Design & Access Statement – Summary of Design Changes

PROPOSED CARE HOME DEVELOPMENT

COLDHARBOUR ROAD, GRAVESEND

Version 04– Nov 2023

Site Plan, summary of Design Changes

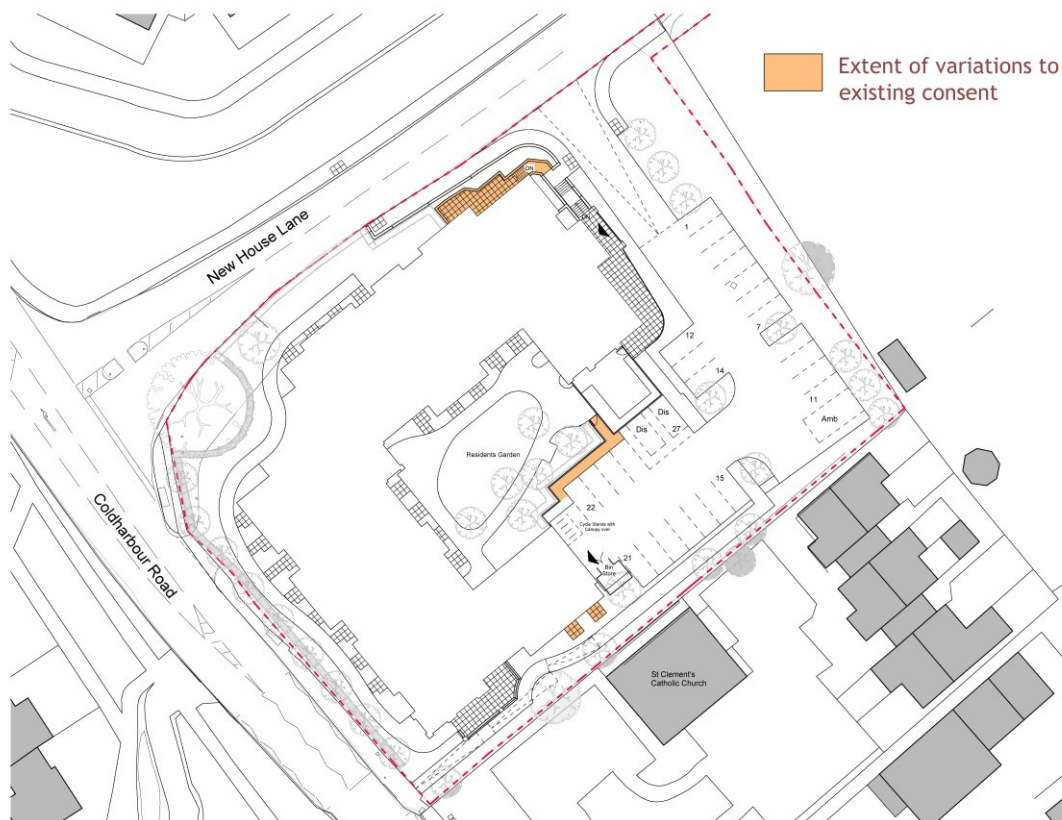
The number of bedrooms in the proposed care home is to be increased by 10 rooms from 65 to 75 with alterations to the internal layout. There is no change to the building envelope with the exception of a minor reduction in the building set back at second floor level above the south east courtyard elevation & some altered windows.

A shallow lightwell has been introduced at the northernmost corner of the care home adjacent to the site entrance to allow access to the new basement level housing staff & back of house facilities.

The addition of bedrooms at ground floor level has introduced 2 No. additional private patio area shown to the south side of the south wing.

A path has been provided adjacent to the residents courtyard garden to link the service drop area with the relocated service entrance.

Second Floor Plan, summary of Design Changes

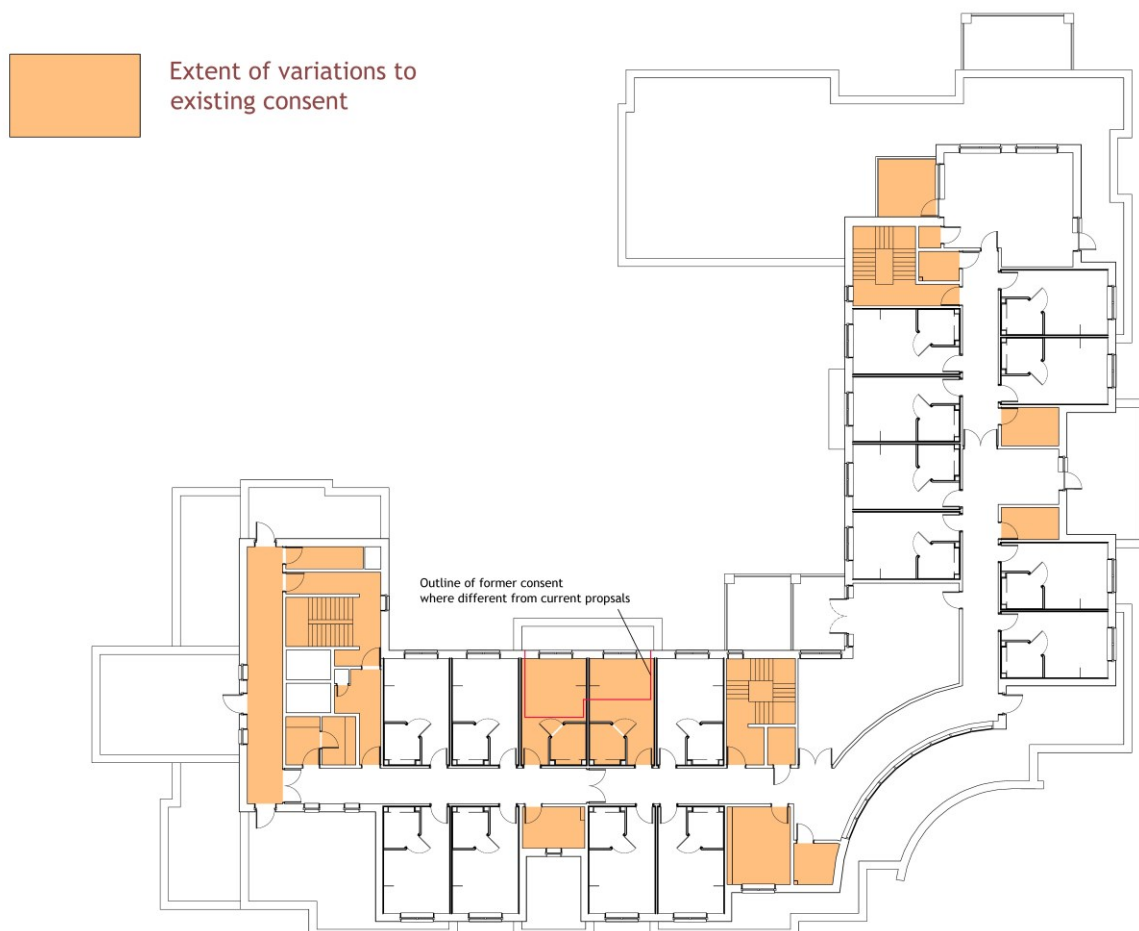
The number of bedrooms to the second floor is increased by 2 No. This is achieved with a small increase in the building footprint infilling a recess in the south east courtyard elevation at this floor level only.

The external terrace to the dining room at the south wing has been relocated to the east side of the dining room to address travel distance issues with the means of escape.

Additional stairs have been added to the central area to cater for means of escape requirements. The Nurse Station & Drug Store has been relocated to accommodate the stair & assisted bathroom in the central area.

The lift to the south wing has been relocated to pair up with the main lift near the main entrance where it can serve the new basement floor.

Staff change, sluice, DSR rooms & Hoist stores have been added in as required by the operator.

Basement Plan, summary of Design Changes

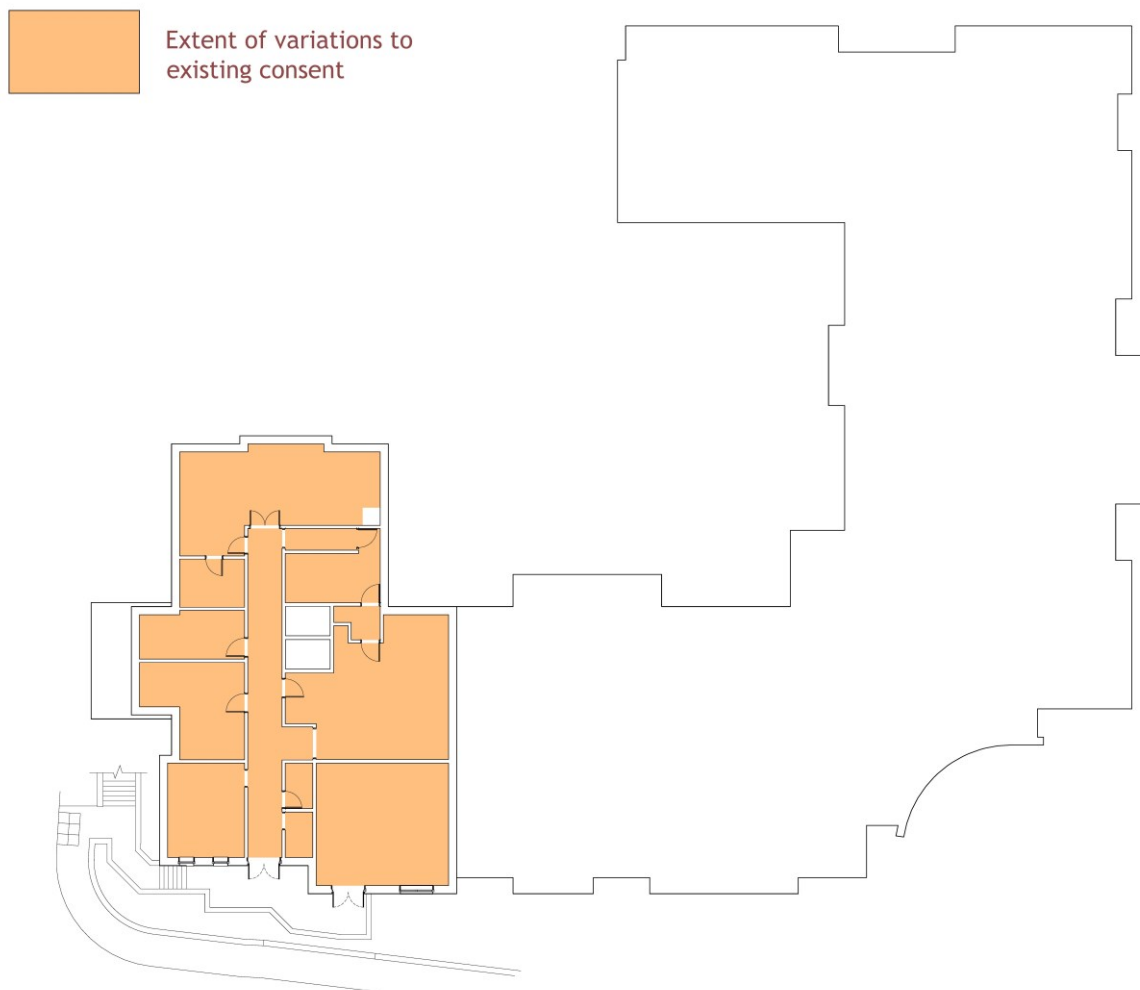
There is no basement to the current consented scheme. A small area of basement accommodation has been added at the north end of the care home footprint adjacent to the site entrance. Here the existing topography of the site is lower relative to the consented ground floor level providing an opportunity to add a lower floor with some natural outlook to the north & east elevations.

The proposed basement accommodation is limited to staff areas with a kitchen, laundry, plantroom & staff welfare facilities.
